IN THE DRAWINGS:

REMARKS

This is intended as a full and complete response to the Office Action dated June 25, 2007, having a shortened statutory period for response set to expire on September 25, 2007. Please reconsider the claims pending in the application for reasons discussed below.

FIG. 8

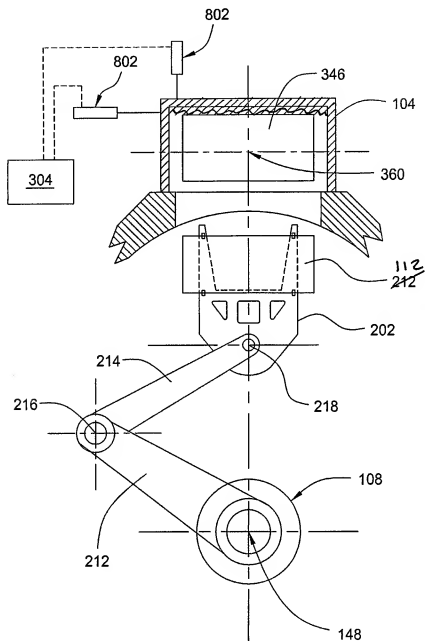
The attached sheet of drawings includes changes to Fig. 8. This sheet replaces the original sheet including Fig. 8. In Fig. 8, 212 has been replaced by 112 to correspond with the specification. Additionally, a minor editorial error regarding cross hatching of item 104 has been corrected.

In amended Figure 8, 212 has been replaced by 112 to correspond with the specification. Additionally, a minor editorial error regarding cross hatching of item 104 has been corrected.
